LaserBase MF5630  
LaserBase MF5650  
LaserBase MF5730  
LaserBase MF5750  
LaserBase MF5770

MF5650-008  
(SH-T01-OLD-10029-01)

Newly setting the label to the rear cover for preventing the cassette paper sensor lever from breaking

P-1 New type REAR COVER

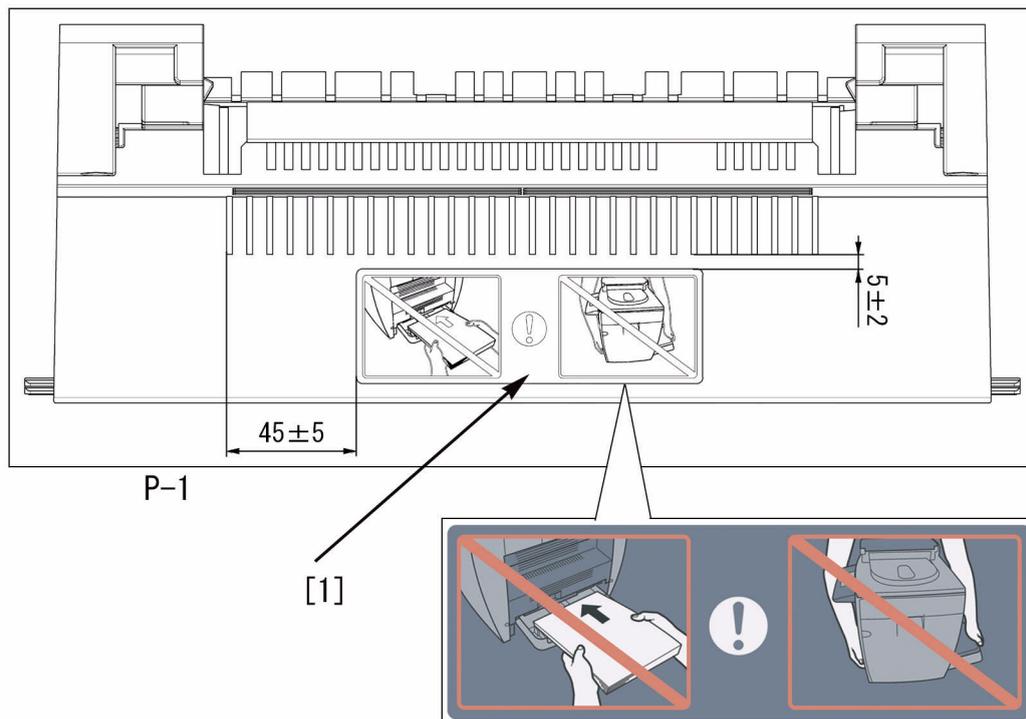
In some cases, the edge of paper comes to contact with the cassette sensor flag and the shaft of the flag is distorted and damaged when operators place paper in the cassette from the rear with the state that the cassette is set to the main body.

Depending on the flag position when it is damaged, the sensor always detects the presence of paper or the absence regardless of actual situations.

Newly set the rear cover label (FC5-8110) and affix it to the rear cover in order to call attentions to users so as not to place paper into the cassette from the rear with the state that the cassette is set to the main body.

When the symptom above occurs, replace the cassette paper sensor lever and affix the rear cover label (FC5-8110) to the rear cover. Or, as new type rear cover (FL2-1753) is set, replace the rear cover with the new one with label (FC5-8110).
